PRELIMINARY PLAT
THE VILLAGES AT MAGNOLIA LANE PHASE 2-3

A SUBDIVISION IN THE CITY OF BRYANT, SALINE COUNTY, ARKANSAS

DATE:	01/11/2021	C.A.D. BY: B.JOHNSON	DRAWING NUMBER:
REVISED:	11/21/2023	CHECKED BY:	19-0238
		SCALE: 1"=100'

THE VILLAGES AT MAGNOLIA LANE PHASE 2-3 UTILITY PLAN

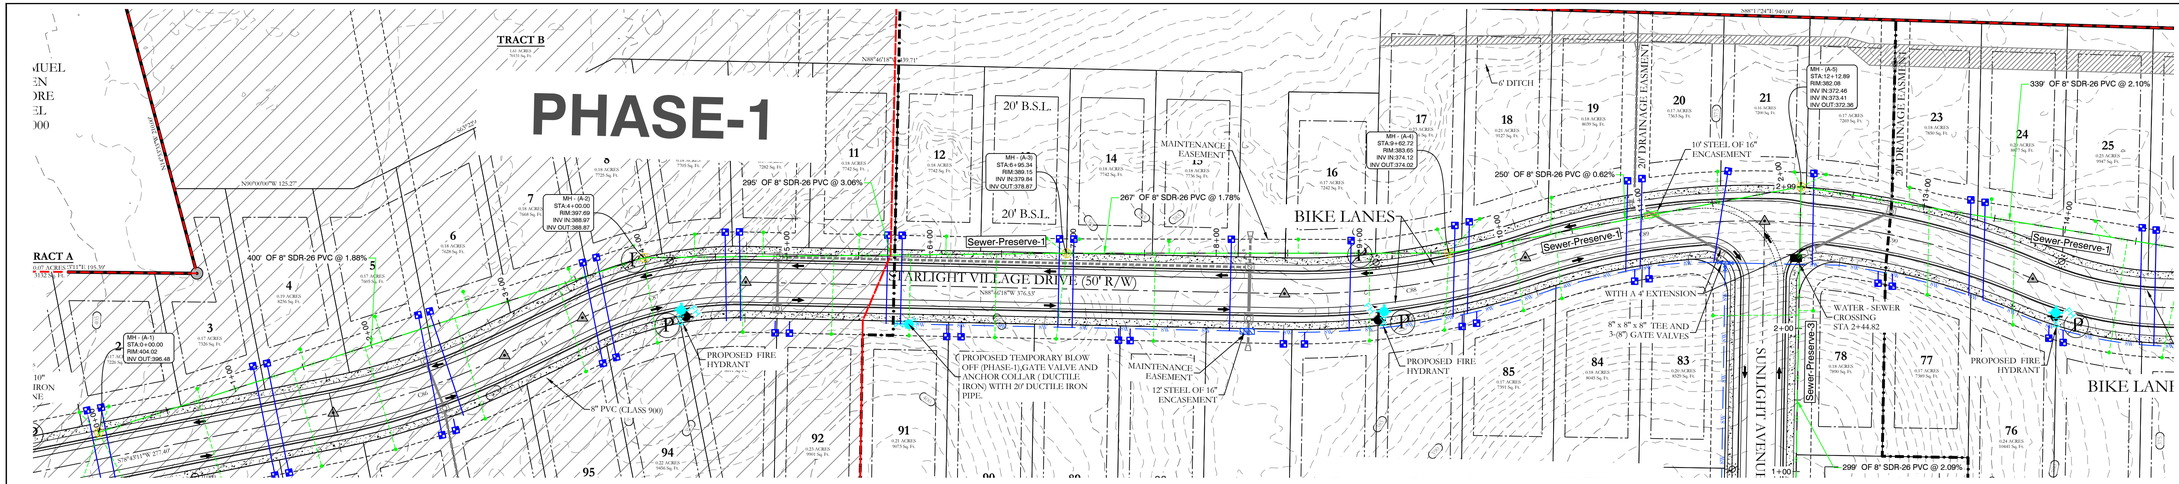
SEE COMMENTS AS ON UTILITY LAYOUT SHEET

THE VILLAGES AT MAGNOLIA LANE PHASE 2-3
TRENCH DETAILS
A SUBDIVISION IN CITY OF BRYANT, SALINE COUNTY, ARKANSAS

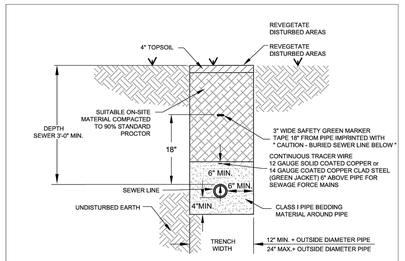
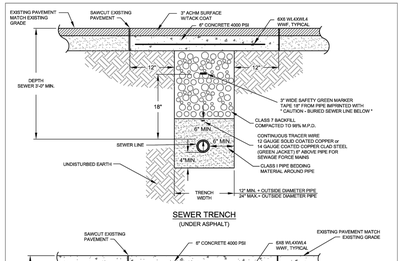
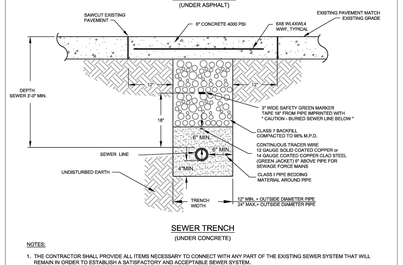
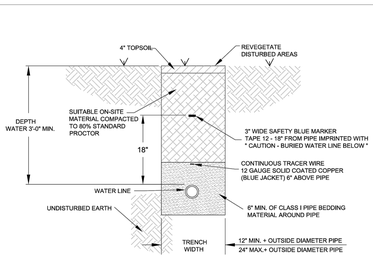
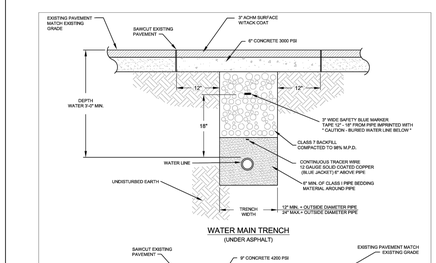
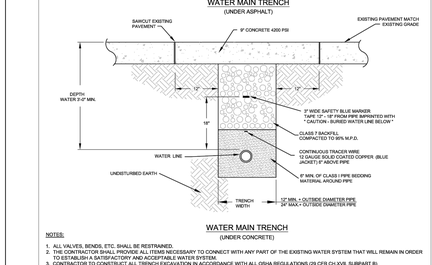
INCLUDE DETAILS FOR

CURB INLETS

DITCHES

RETENTION PONDS (LAYOUTS, SECTIONS, PIPE DRAIN, SPILLWAY, ETC.)

STORM PIPE TRENCH

STORM PIPE FLARED END SECTIONS

RIPRAP DETAIL

FENCING?

THRUST BLOCKS?
